**Re: San Roque & La Sorena  
441 & 457 Coors Blvd. NW  
Conceptual Traffic Circulation Layout for DFT Approval  
Engineer's Stamp 10-04-23 (J10-D049)**

**RE: SAN ROQUE & LA SERENA  
441 & 457 COORS BLVD. NW  
TRAFFIC CIRCULATION LAYOUT - RESPONSE TO COMMENT**

**Traffic Circulation Layout**  
**c5.0**

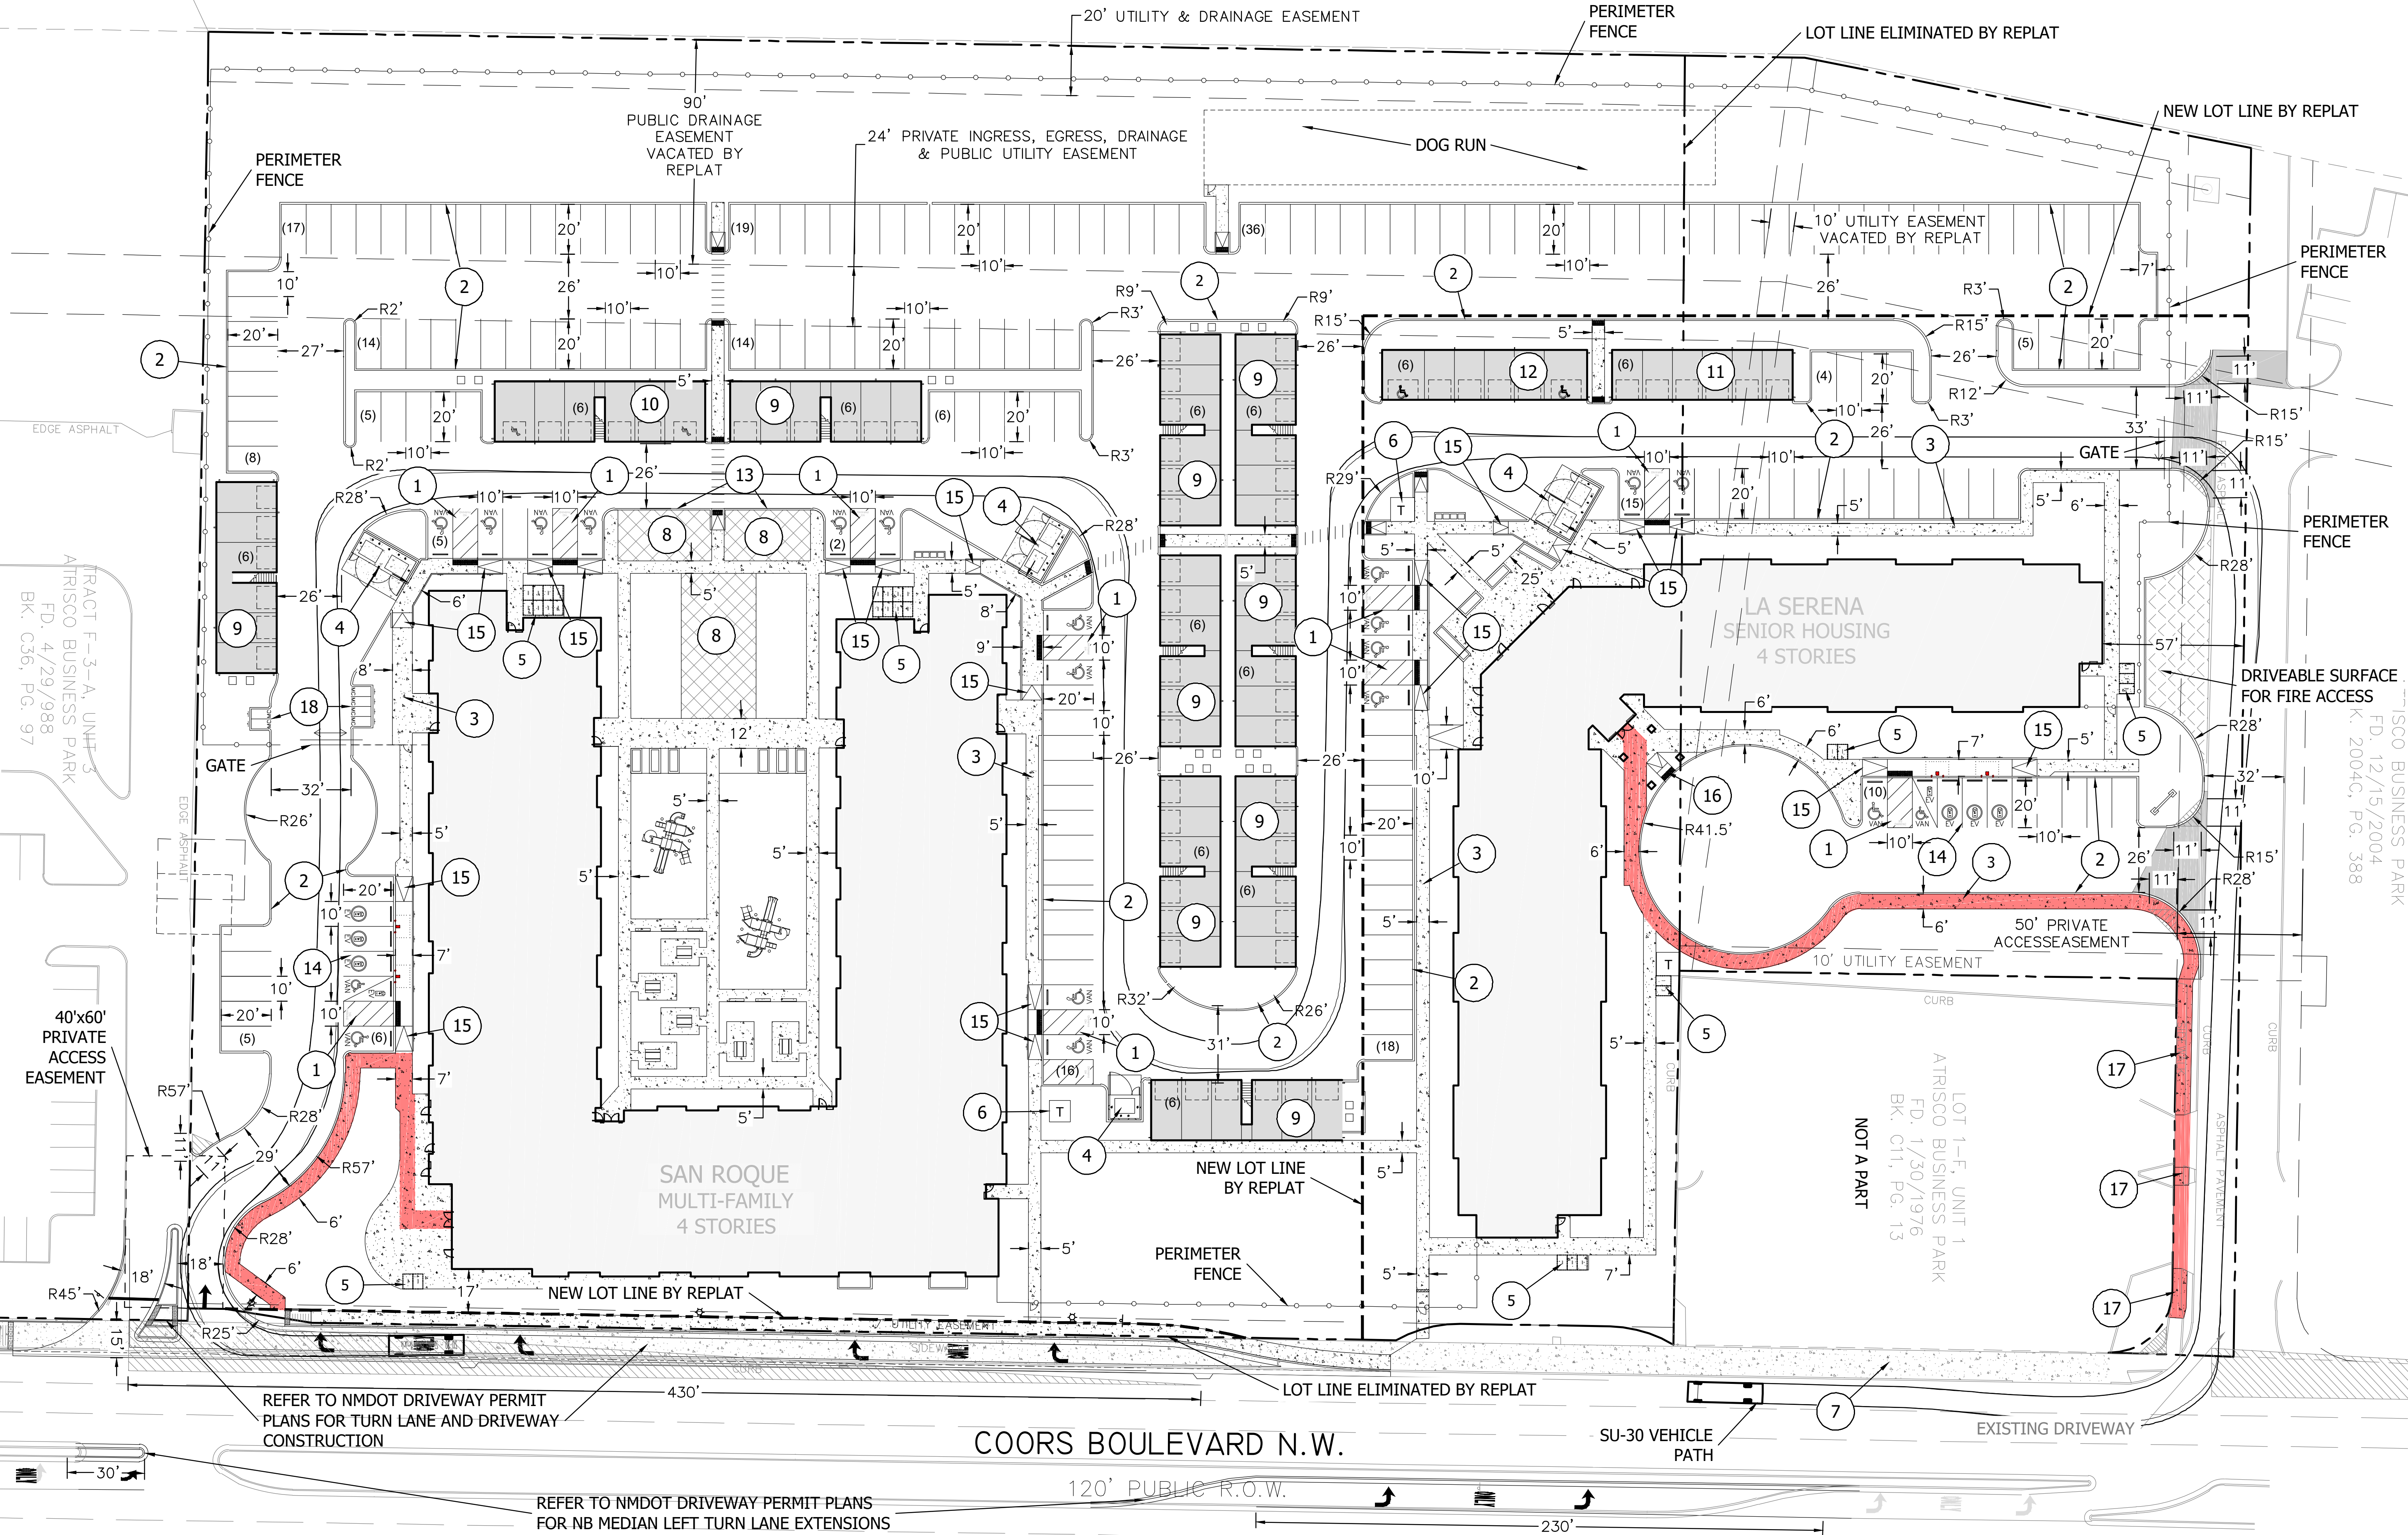
2. List the number of Motorcycle parking spaces required by the IDO.  
**Response: The motorcycle parking and provide numbers are provided under the “SITE PARKING DATA-OVERALL” section of the plan. The parking spaces are also called out with Keyed Note 18.**

3. Identity all existing access easements and rights of way width dimensions.  
**Response: All access easements and Coors right-of-way widths are now shown on the plan.**

5. Sidewalk must be improved from property line to property line at the north side of the site.  
**Response: The sidewalk along the north property line is called out to be removed and replaced to be 6’ wide with Keyed Note 17.**

7. Please show on the site plan this drive aisle width and this ADA route width.

8. Motorcycle parking spaces shall be designated by its own conspicuously posted upright sign, either free-standing or wall mounted per the zoning code.

9. The pavement marking "MC" should be shown in the opposite direction for motorcycles entering the parking space.

15. Per DPM, a 6 ft. wide ADA accessible pedestrian pathway is required from the ADA parking stall access aisles to the building entrances. Please clearly show this pathway and provide details.

16. ADA accessible pedestrian pathway should not be placed behind parking space or adjacent to a vehicular way. Vehicle and pedestrian/wheel chair conflicts should be avoided as much as possible.

**Response: These dimensions have been added.**

**Response: Keyed Note 18 calls out the spaces to include signage.**

**Response: The pavement markings are shown in each motorcycle parking space and Keyed Note 18 calls out the spaces to include pavement markings.**

**Response: All main ADA pedestrian pathways to the main entrances show a minimum 6' wide sidewalk from the parking stalls.**

**Response: All ADA pathways are placed in front of the parking stalls and away from the vehicular ways.**
17. All sidewalks along streets should be placed at the property line.
